Access Compliance Report Public Rights-of-Way (Curb Ramps)

Main Street: ORANGE_AVE Cross Street: ROSEBAY_ST Location: SE

ADA ID: RPRK210927120340 Ramp Type: Type 1 - Perpendicular Diagonal Initial Pass/Fail: Fail Overall Compliance: No Severity Score: 2

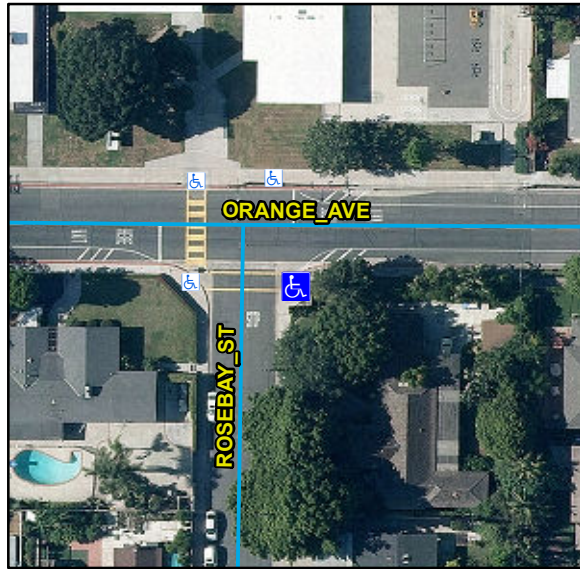
Compliance	Description	Data	Compliance	Description	Data
N/A	Ramp Length (in)	125	N/A	Flare Type LT	
Yes	Ramp Width (in)	48			N/A
Yes	Ramp Run Slope (%)	6.2	N/A	Flare Slope LT (%)	N/A
No	Ramp Cross Slope (%)	3.8	N/A	Flare Traversable LT	N/A
N/A	Landing Present	N/A	N/A	Flare Type RT	
N/A	Landing Length (in)	N/A			N/A
N/A	Landing Width (in)	N/A	N/A	Flare Slope RT (%)	N/A
N/A	Landing Run Slope (%)	N/A	N/A	Flare Traversable RT	N/A
N/A	Landing Cross Slope (%)	N/A	N/A	DWS Provided	N/A
N/A	Landing Movement Obstructed?	N/A	N/A	DWS Contrast	N/A
	Landing Movement Type	N/A	N/A	DWS Length (in)	N/A
N/A	Landing Shared	N/A	N/A	DWS Full Width	N/A
N/A	Clear Space	Yes	N/A	DWS Offset Left (in)	N/A
N/A	Clear Space To Crosswalk (in)	N/A	N/A	DWS Offset Right (in)	N/A
N/A	Marked Crosswalk 1	No	N/A	Marked Crosswalk 2	Yes
	Crossing 1 Direction	N		Crossing 2 Direction	W
	Marked Crosswalk 1 Width (in)	N/A		Marked Crosswalk 2 Width (in)	92

Remove & Replace Curb Ramp With Two New Directional Ramps or Equivalent.
